**CITY OF FREDERICKSBURG
HISTORIC REVIEW BOARD
TUESDAY, APRIL 12, 2022 @ 5:30 P.M.
LAW ENFORCEMENT CENTER at 1601 E. MAIN ST**

7. CERTIFICATE OF APPROPRIATENESS APPLICATIONS

**HISTORIC REVIEW BOARD
MARCH 15, 2022
5:30 PM**

510 E Creek

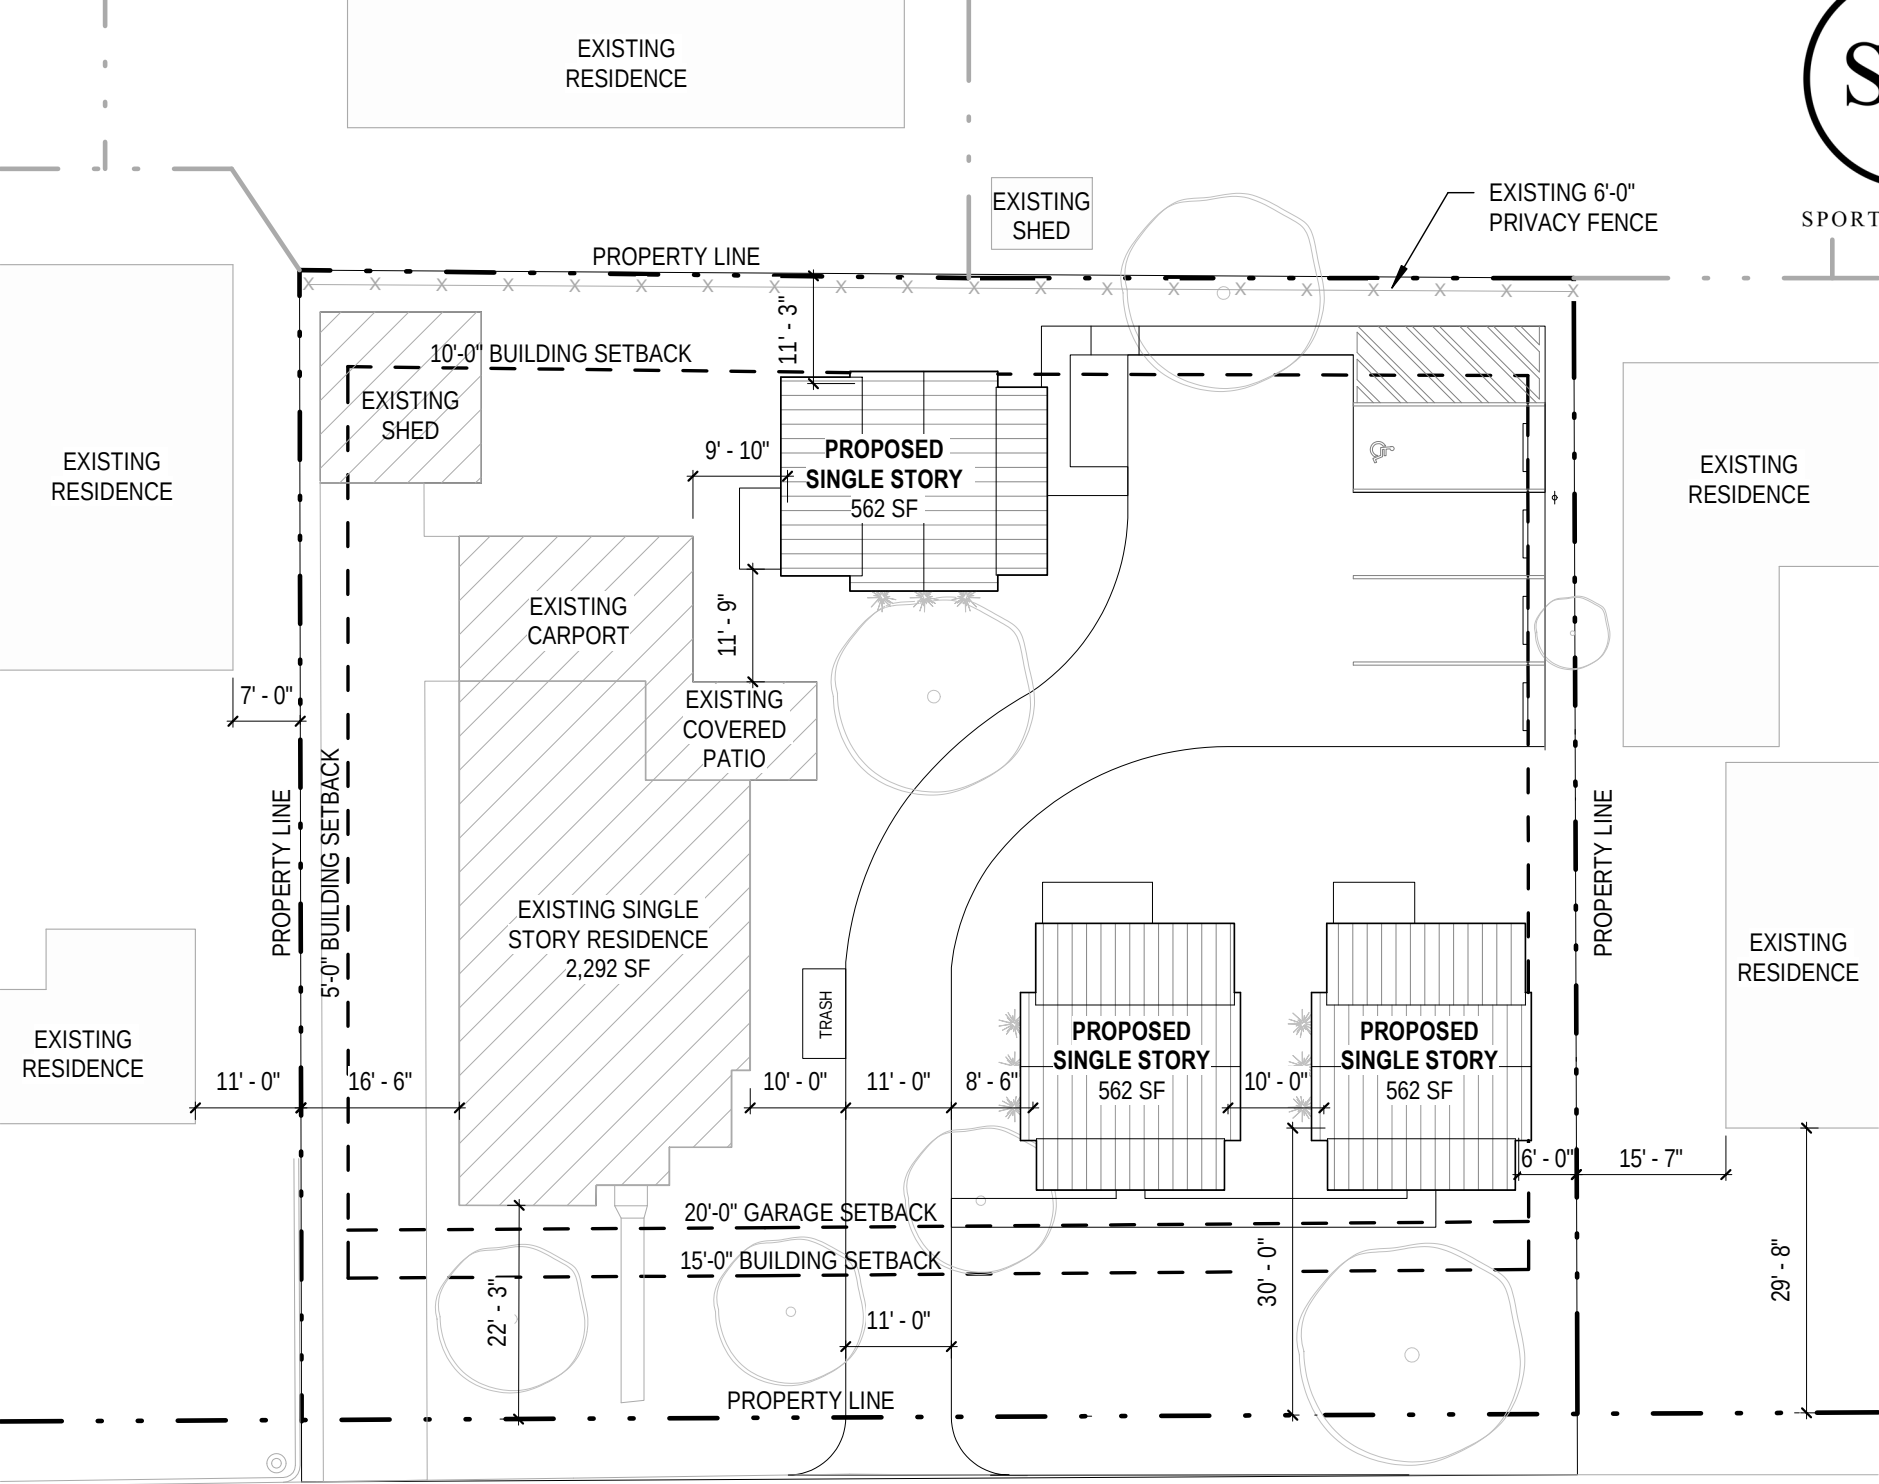
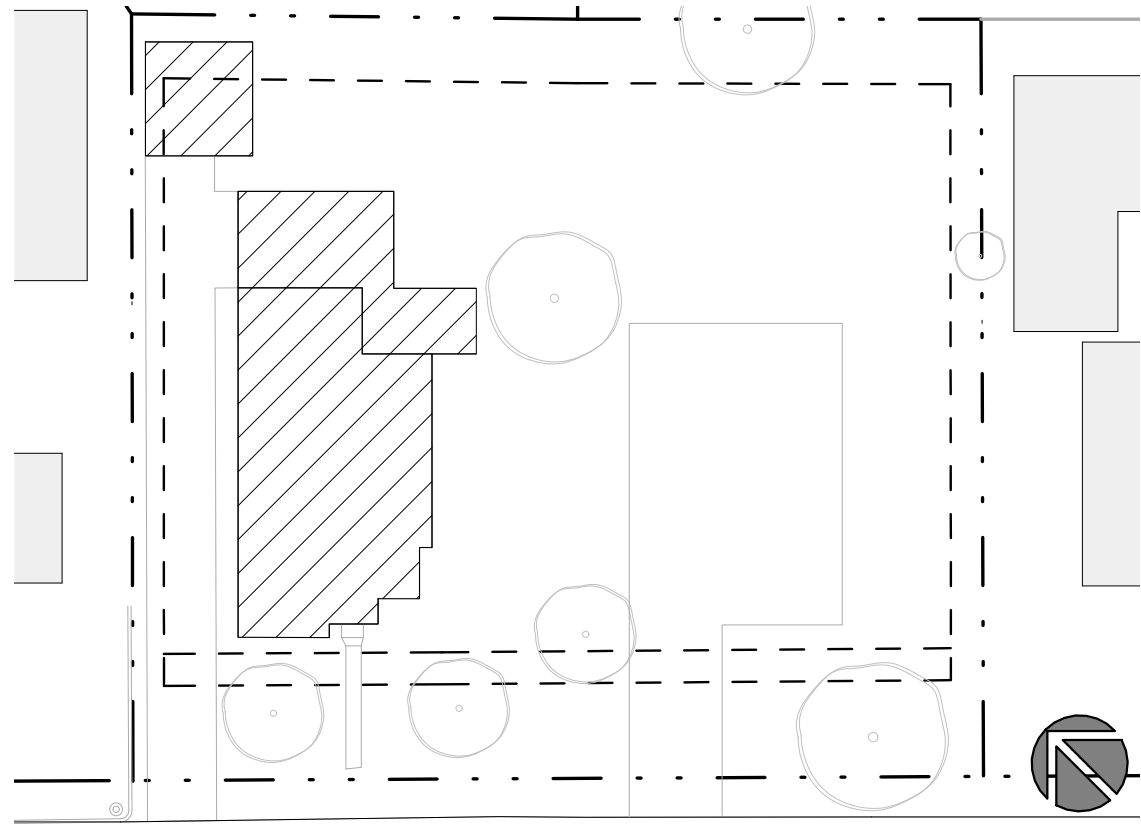
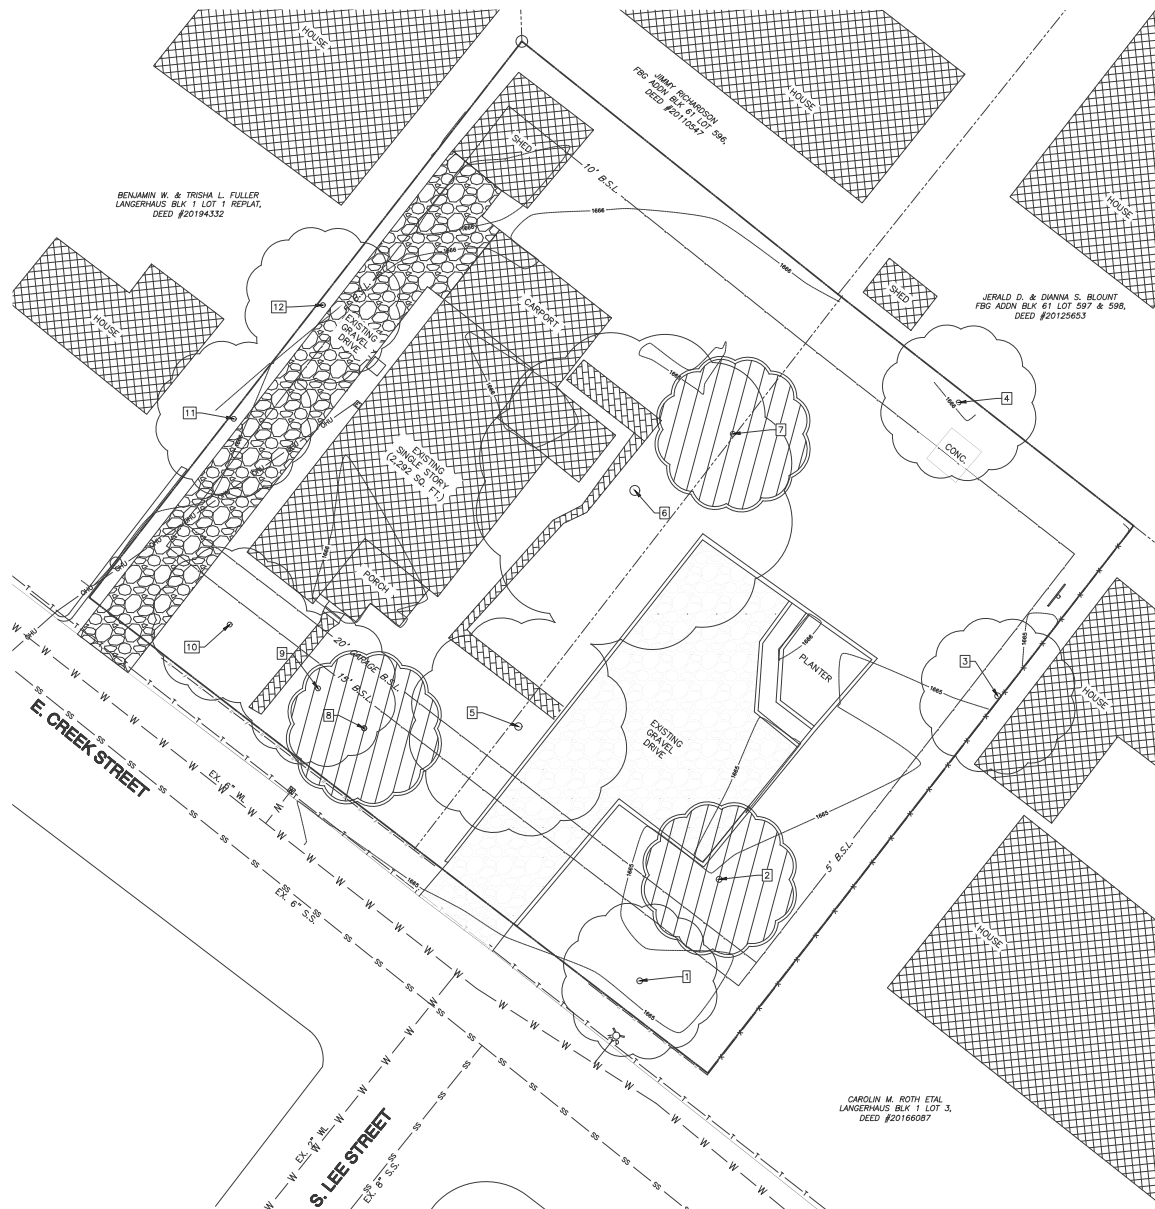
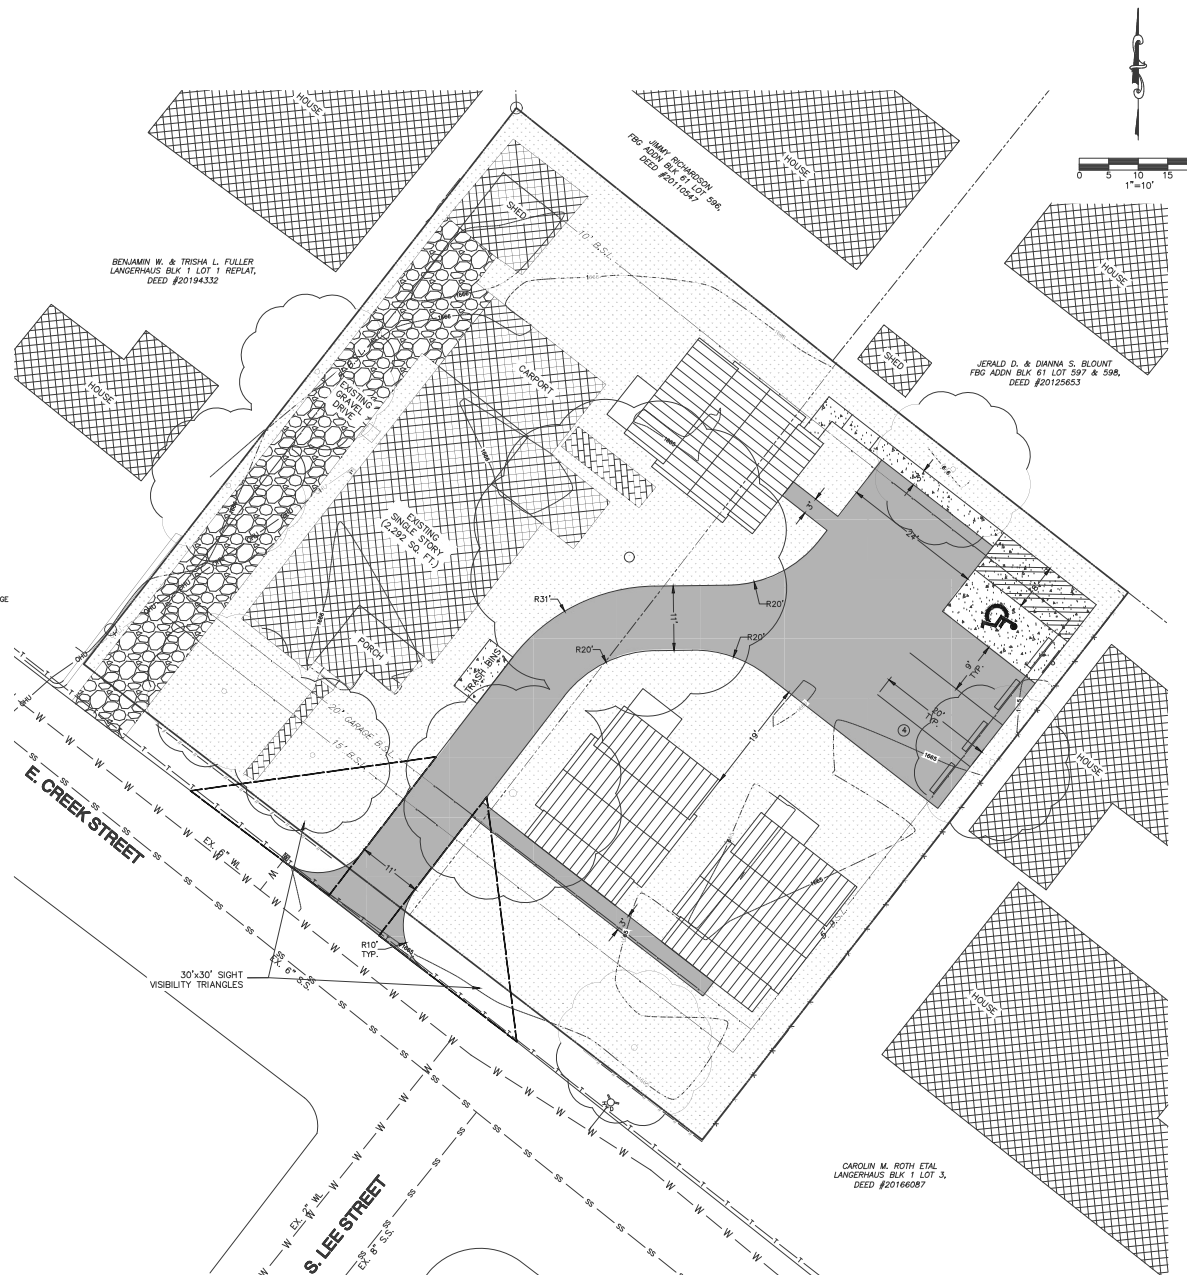
1. The proposed new cottages are appropriate in design and materials. The first design presented at Historic Review Board in March had a different site layout. The proposed changes to the layout are more in keeping with the traditional site layout/development pattern of similar sized lots. Combining the two new front structures to have a more typically sized house up front with one small cottage behind, would be much more in keeping with the development pattern of the neighborhood and would meet the requirements of section 3.4.3 (e). This recommendation is in keeping with the Design Guidelines and Standards cited above.
